Final Environmental Impact Report

San Marcos Creek Specific Plan and Floodway Improvement Project

San Marcos, California

Section 0.3 Responses to Comment Letters Received on the Draft EIR

FIGURE 1.0-3

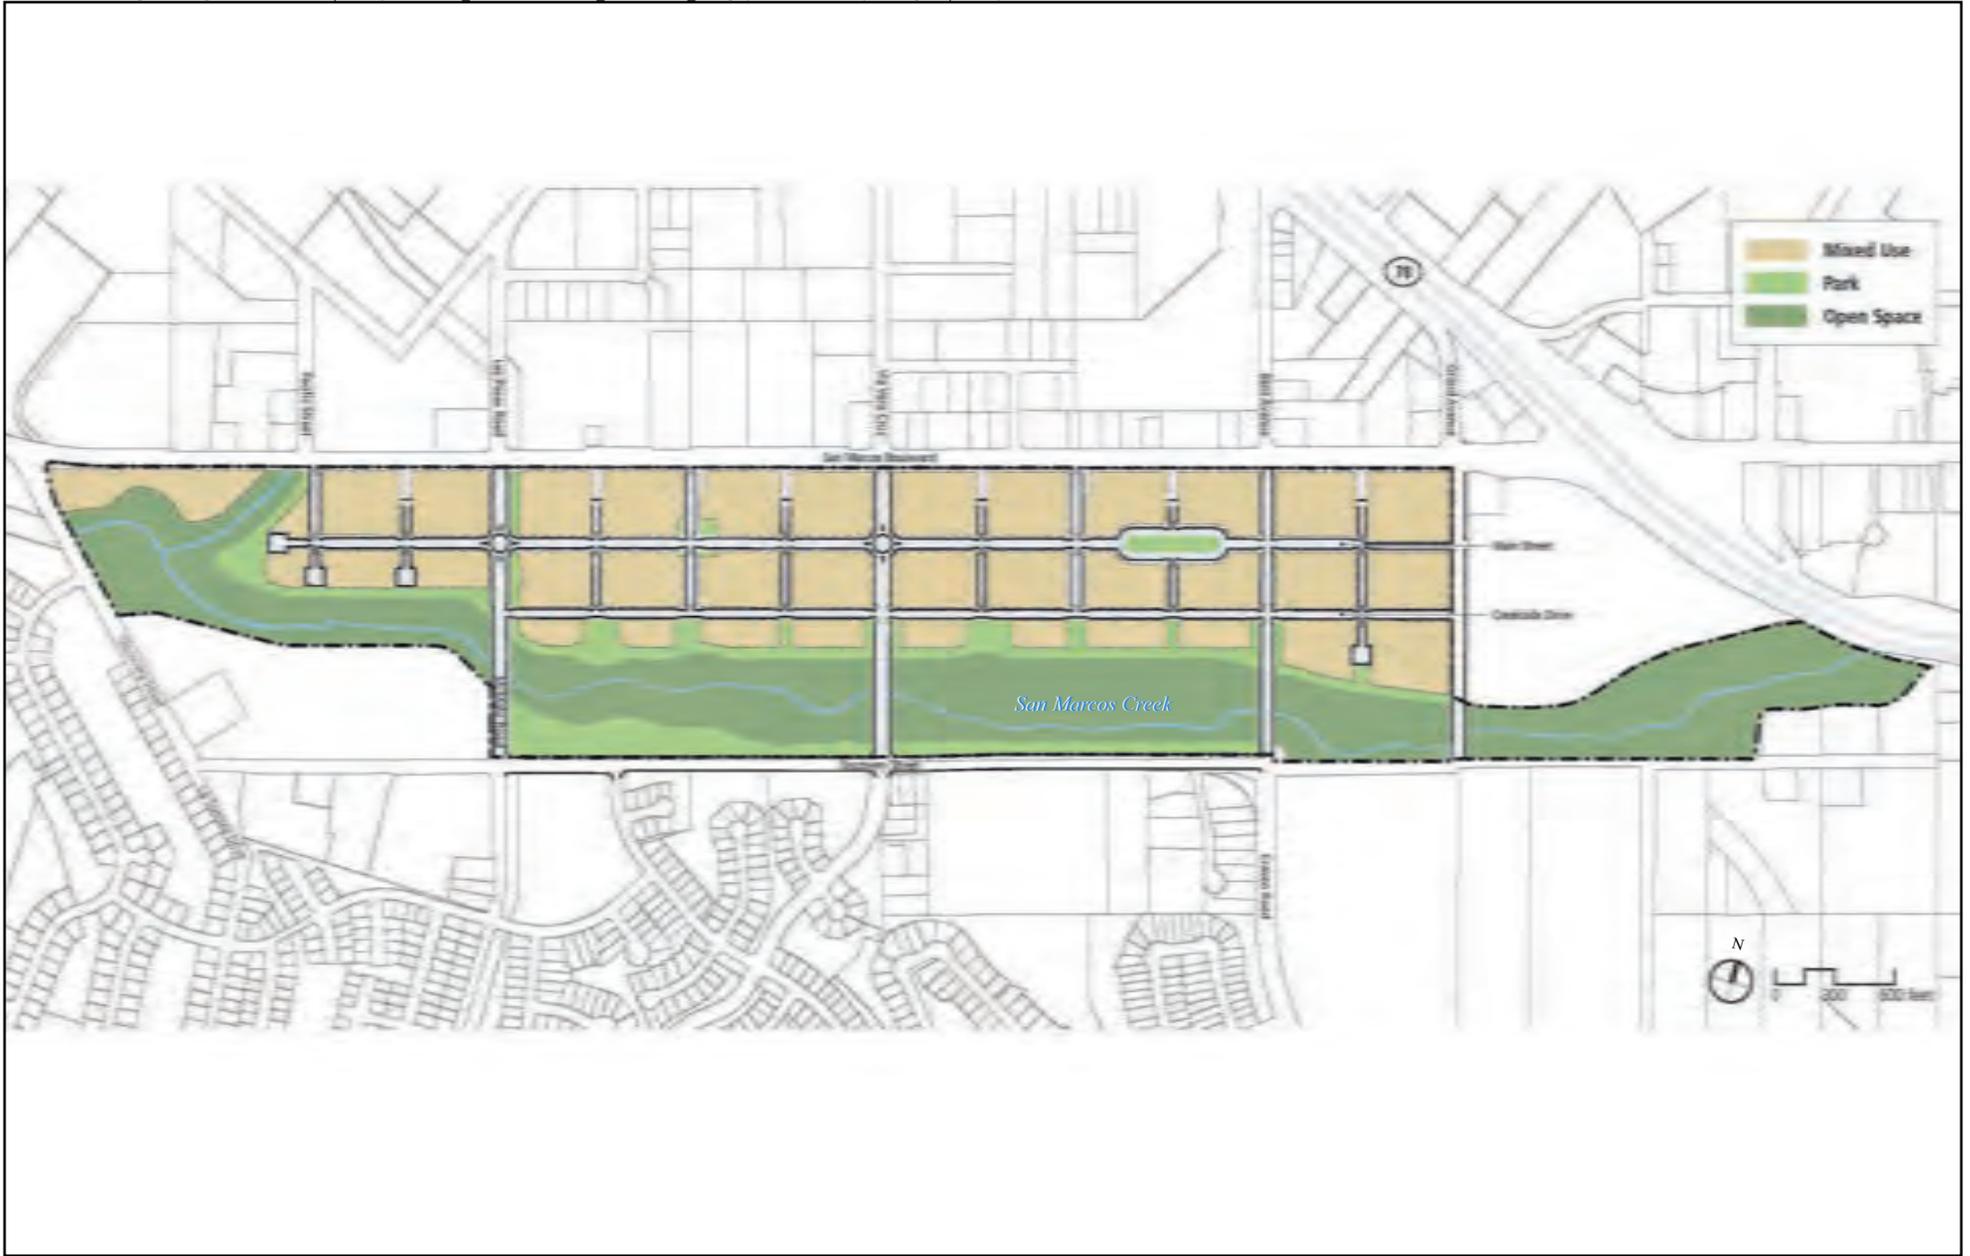
Final EIR Section	Page Number
1.0 Executive Summary	Pages 1-1, 1-3, 1-10, 1-11, 1-12, 1-13, 1-18, 1-19, 1-20, and 1-30 Table 1.7-1, 1.8-1, 1.8-2 Figure 1.0-3 revised to show new Site Plan

The San Marcos Creek Specific Plan area covers approximately 217.3 acres. This includes 81.7 acres proposed as mixed use development, 19.9 acres of park, 77.0 acres of open space, and 38.47 acres of right-of-way. Figure 1.0-3 depicts the distribution of the land uses.
